**ABP-314232**

**For:** DART+ West Railway Order - Dublin City to Maynooth and M3

## **ORAL HEARING**

*Excerpts from 'before and after' photo montage images taken from the historic centre of Clonsilla Village and opposite the protected structure of St Mary's Church (taken from the DART+ West Railway Order Application*

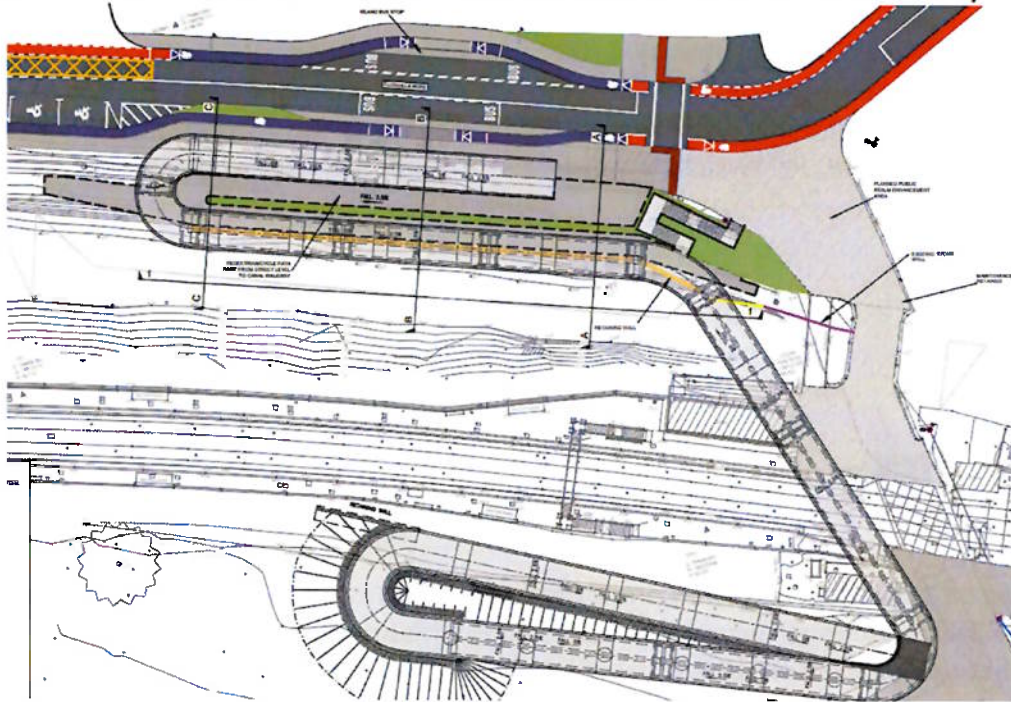
The bridge at Clonsilla Station is proposed to span the Royal Canal to the West of the Callaghan Bridge. With its current alignment of the proposed this concrete structure will cause irrevocable harm to both the visual amenity and the loss of all mature trees and hedgerow along the northern bank of the Royal Canal and along the Clonsilla Road

Excerpt from GA Plan layout (sheet 1 or 2)

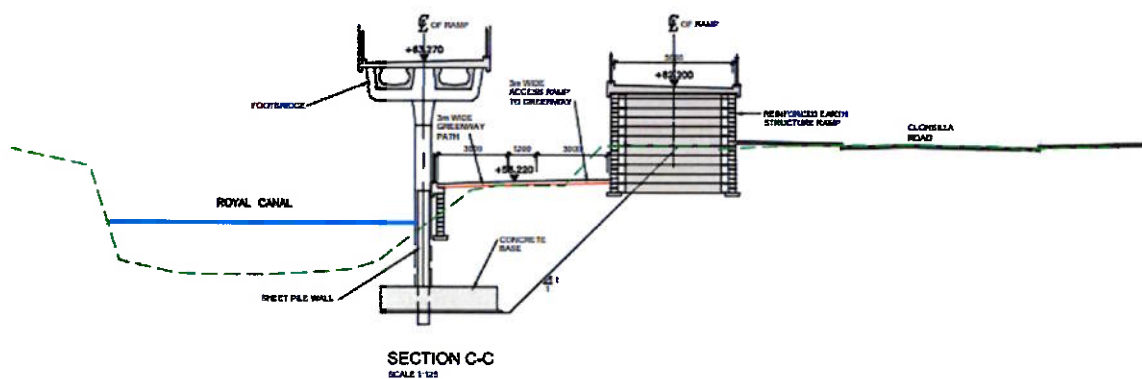
The proposed alignment of this bridge will also result also result a line of four large columns along with a retaining wall, being cut into the Royal Canal (which we note is a proposed National Heritage Area) , with the unsightly and massive structure and 6 metre wide deck looming over the towpath for approximately 50 metres, which once again will cause irrevocable harm to both the visual amenity and to biodiversity of the canal and canal bank. (see excerpts taken from Dart + West Consultation No.2- vol. 3J)

In order to mitigate highlighted harm which will be caused by current proposals, we recommend that the applicant be requested to re-design the northern leg of the bridge as a single run, running east – west, which can be accessed directly from both cycle and footpaths on Clonsilla Road. This re-alignment will allow for the deck and support to be moved northwards and away from the Royal Canal.

Also in order to reduce the visual obtrusiveness caused by the proposed massive and bulky precast concrete design (especially in the environs of the protected structures in this location), we request that the applicant be conditioned to adopt the visually less obtrusive and slender CORTEN clad, lightweight steel design of proposed bridges at Ashtown and Coolmine.
